CITY OF ST. PETERSBURG, FLORIDA
PLANNING AND DEVELOPMENT SERVICES DEPARTMENT
URBAN PLANNING AND HISTORIC PRESERVATION DIVISION

STAFF REPORT

Community Planning and Preservation Commission Certificate of Appropriateness Request

Case No.:	21-90200083
Address:	501 5 th Avenue Northeast
Legal Description:	VINOY REPLAT BLK 1, PT OF LOT 1 (HISTORIC LANDMARK HOTEL) (VINOY HOTEL PH 1&2 LEASE TO FEB 22, 2090) DESC BEG NE COR OF LOT 1 TH S12DW 69FT TH CUR LT RAD 5767.87 FT ARC 136.52FT CB S09DW 136.51FT TH W 620.9FT TH S 397.58FT TH W 916.7FT TH N 112.06FT TH N32DE 334.99FT TH E 169FT TH N30DE 155.44FT TH E 78.45 FT TH N 67.52FT TH E ALG 7TH AVE NE 1072.5FT TO POB CONT 10.72 AC(C)
Parcel ID No.:	17-31-17-94240-001-0010
Date of Construction:	1925

Figure 3: Existing (left) and proposed (right) elevation drawings of the porte cochere and restored portal.

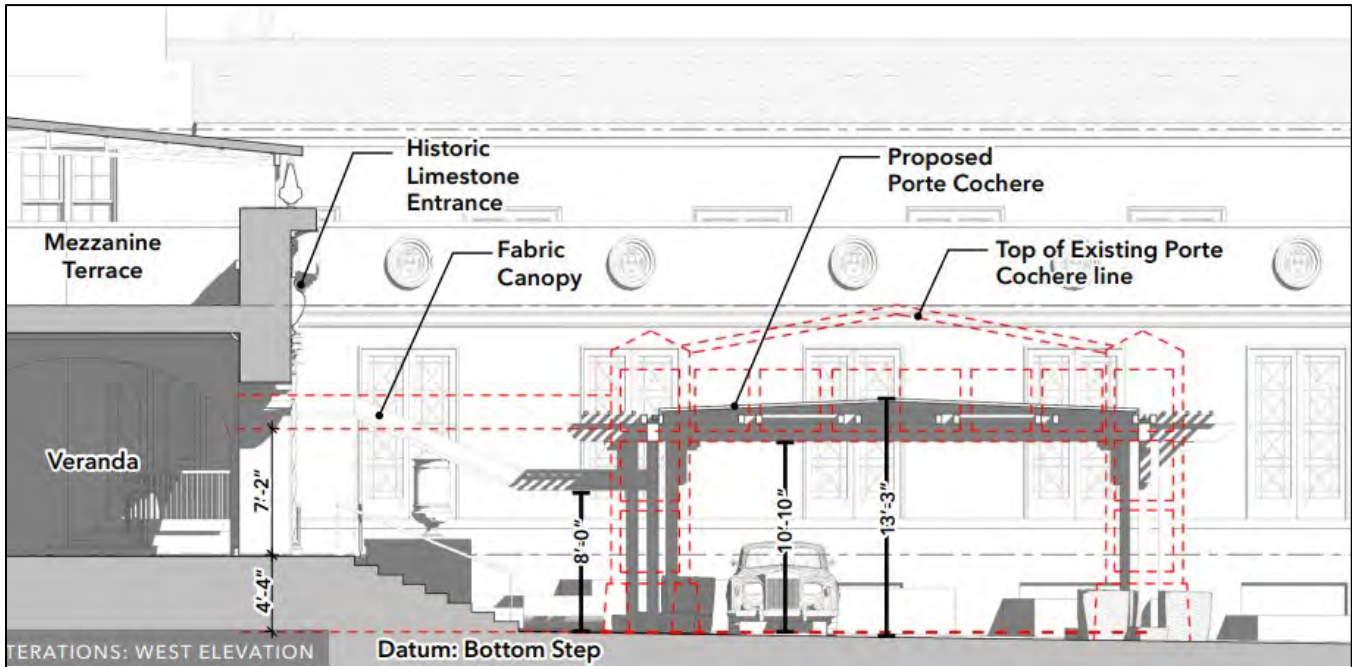
The proposal will not substantially affect the integrity of the local historic landmark. The most visible alteration proposed will be the new porte cochere in the front of the main entrance. While the new porte cochere will be approximately nine feet wider and six feet longer in footprint, it will be five feet shorter than the existing 18-foot tall porte cochere. The structure will have a painted aluminum frame with a Knotwood cladding material in Driftwood color that tries to replicate the appearance of weathered wood. The structure will have a clear laminated glass covering over the aluminum frame. Two fabric canopies will attach the porte cochere to the hotel.

The proposed structure has been designed in a more transparent way than the existing porte cochere with thin structural posts. Staff believes that the new porte cochere, based on traditional pergola design, will be more compatible with the historic building and will improve the visibility of the intricate and highly ornate portal.

The Vinoy | 1 - Motorcourt & Porte Cochere

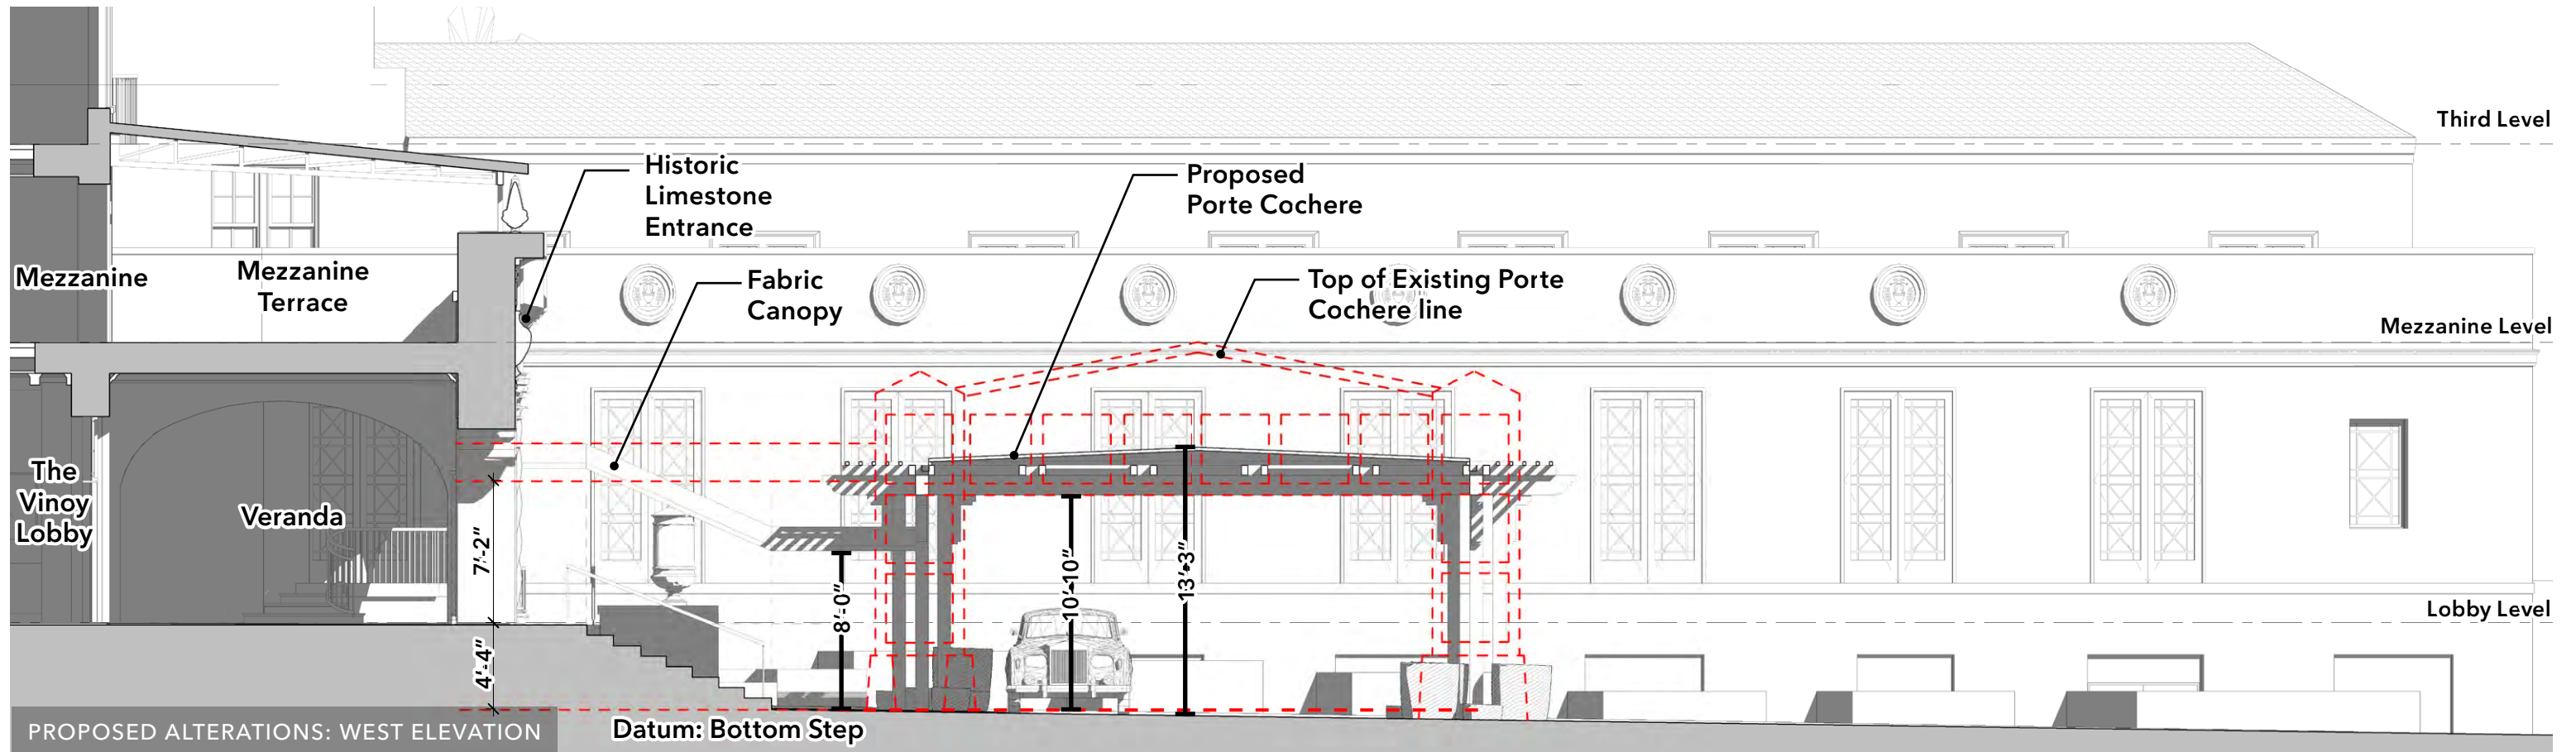
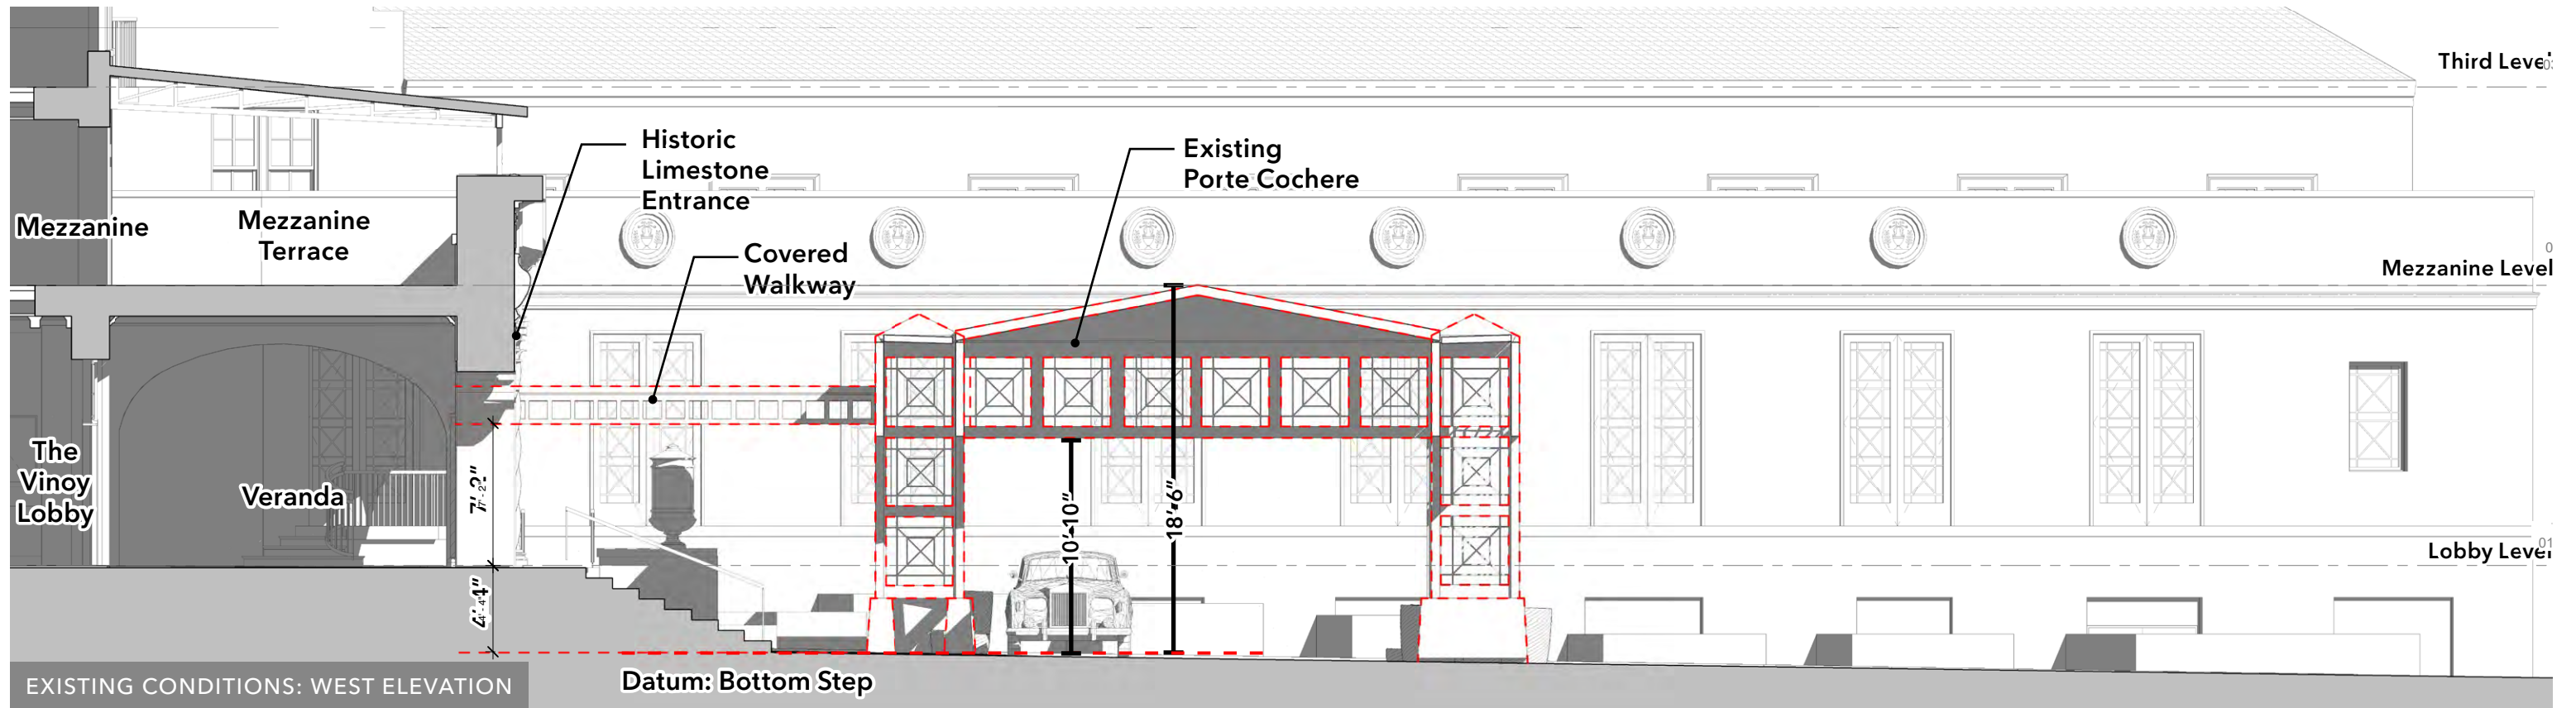
The proposed addition of the new porte cochere will be located directly in front of the historic structure and main hotel entrance, but the porte cochere will be replacing an existing porte cochere that currently obscures the ornate portal, which is a character defining feature of the building. While the best practice would be to remove the porte cochere completely, the applicant feels that a porte cochere structure is needed for the hotel to function in modern times.

Staff feels that the proposed porte cochere will be an improvement over the extant structure.

Consistent The proposal includes the removal of non-historic alterations that were most likely done during the early 1990s renovation period. While the application proposes new features (mainly the new porte cochere and the entry stairs on the east wing), these could be easily removed at a later date without detriment to the structure. As stated above, staff finds the new porte cochere to be a much more appropriate design for the hotel.

The Vinoy | 2 - Decks & Patios

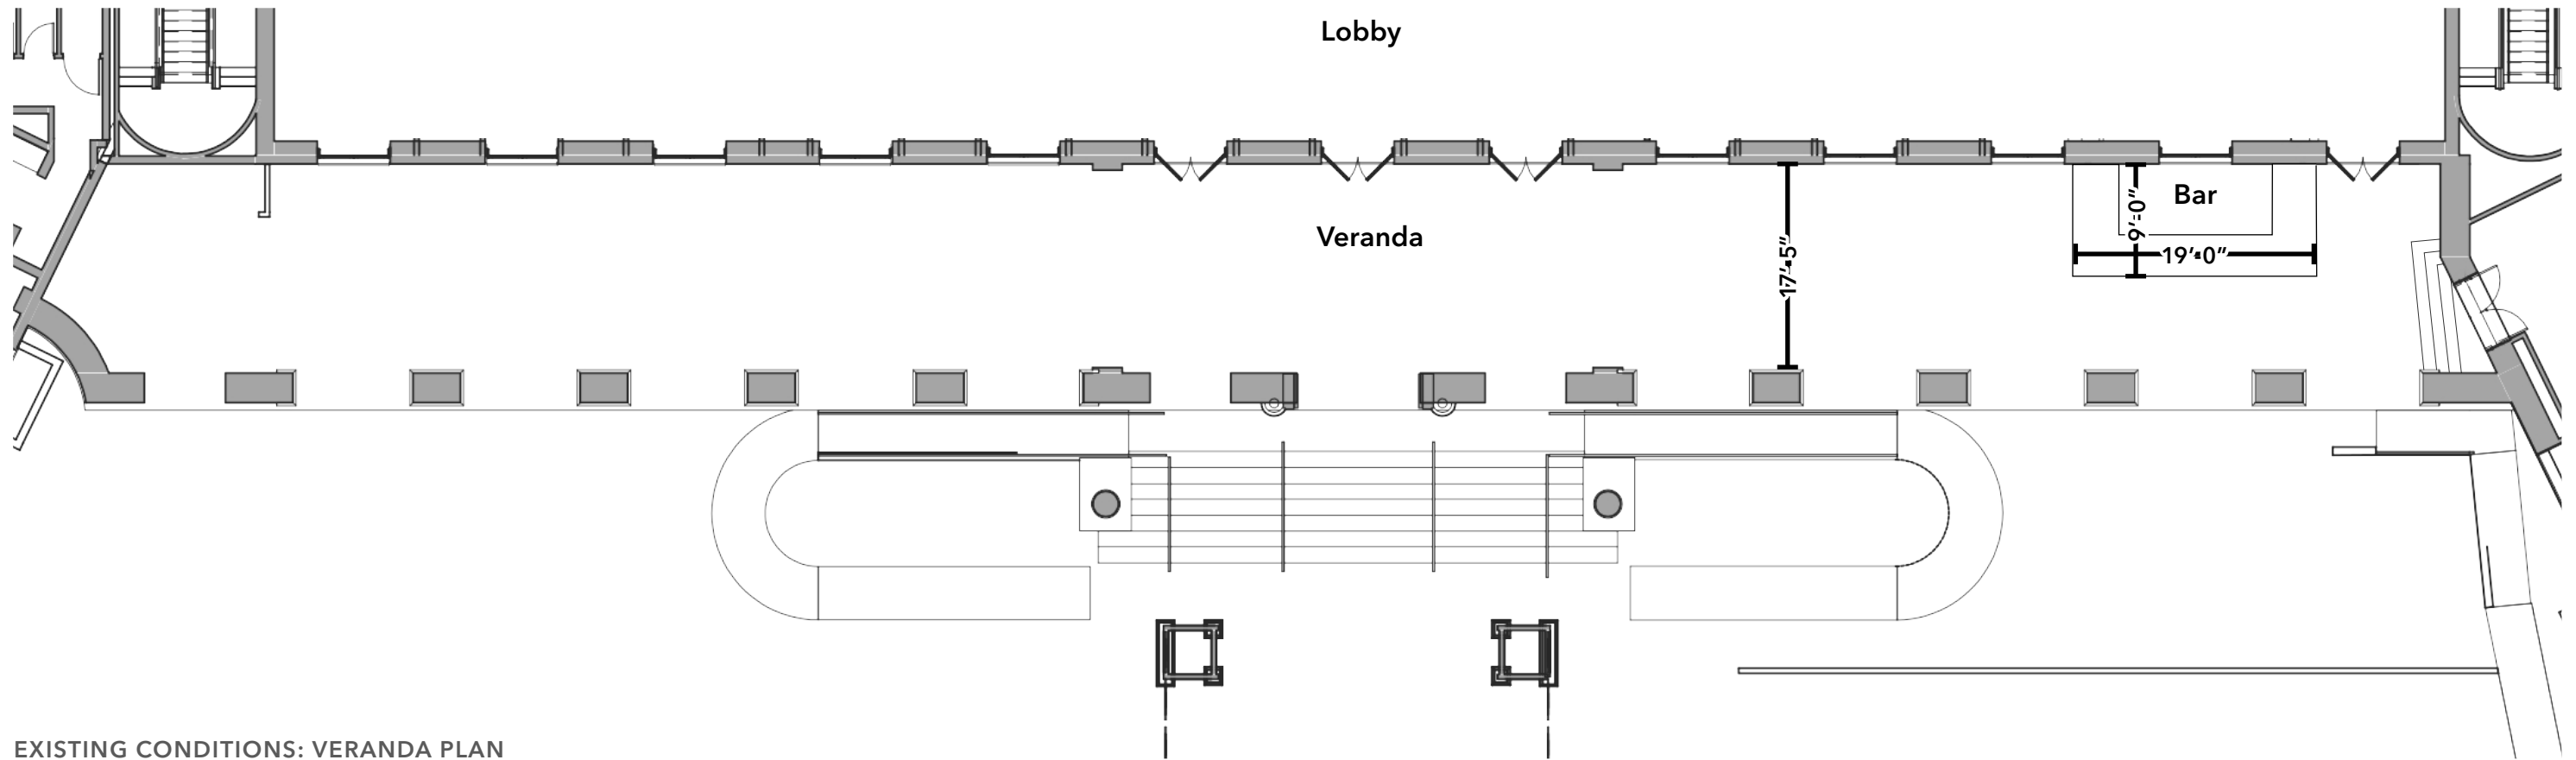
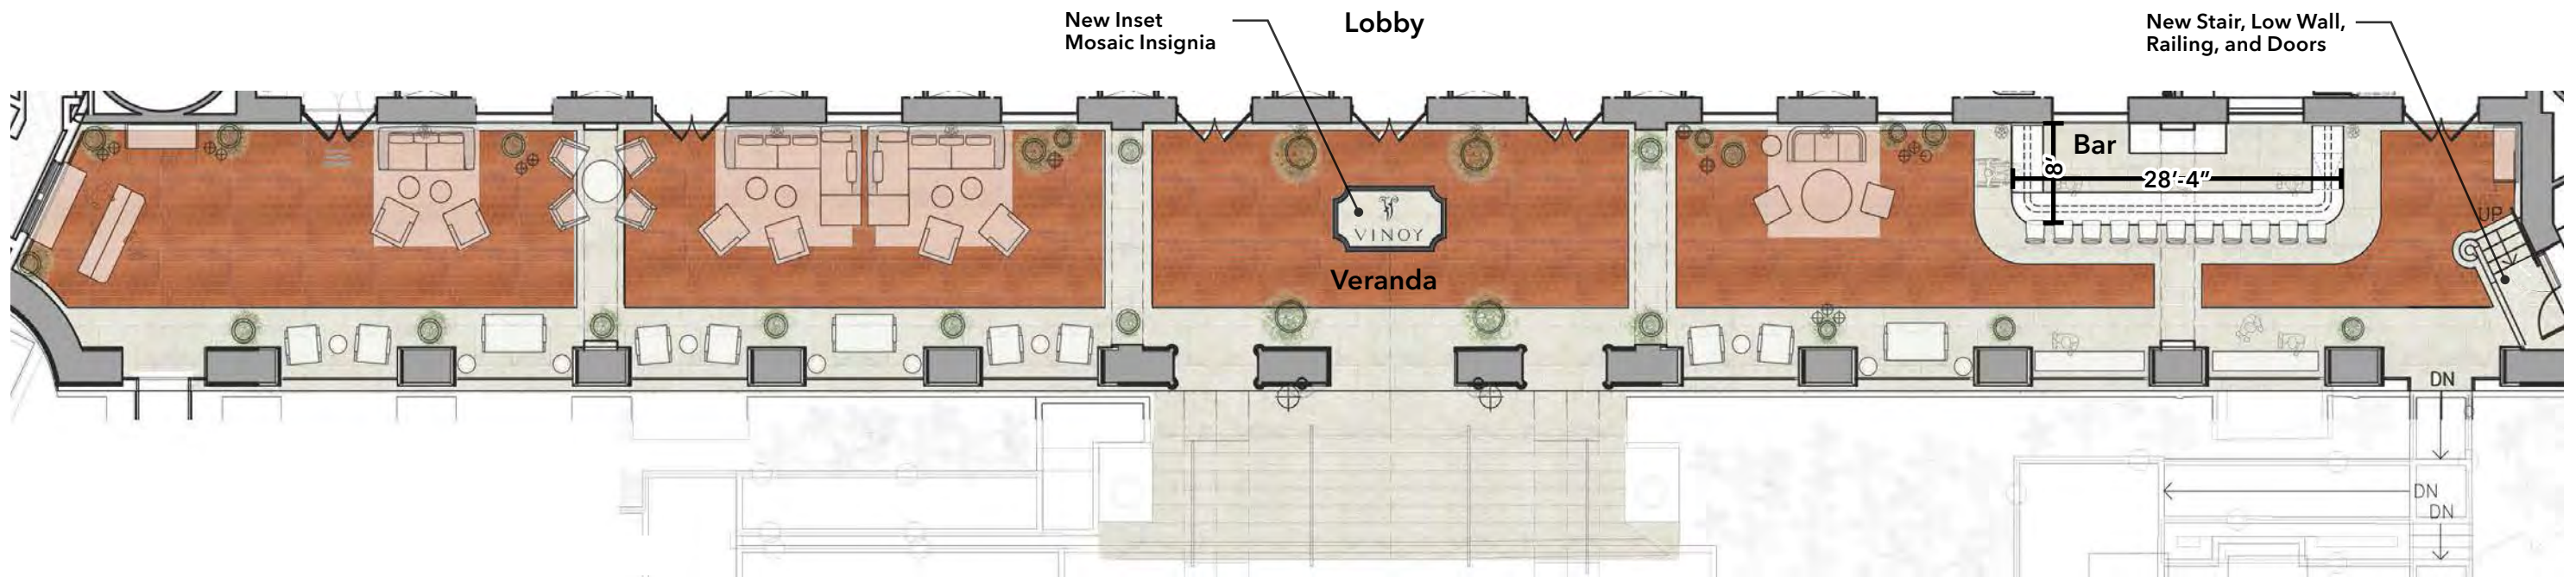
The application includes work on the front verandah, such as new flooring that more closely matches the flooring documented in historic photographs, a new bar to replace an existing bar, and new railings that meet current code. Historic photographs show that the verandah didn't originally have railings, and the bar is a modern improvement. Both of these items are easily reversible and won't have a detrimental impact on the landmark.
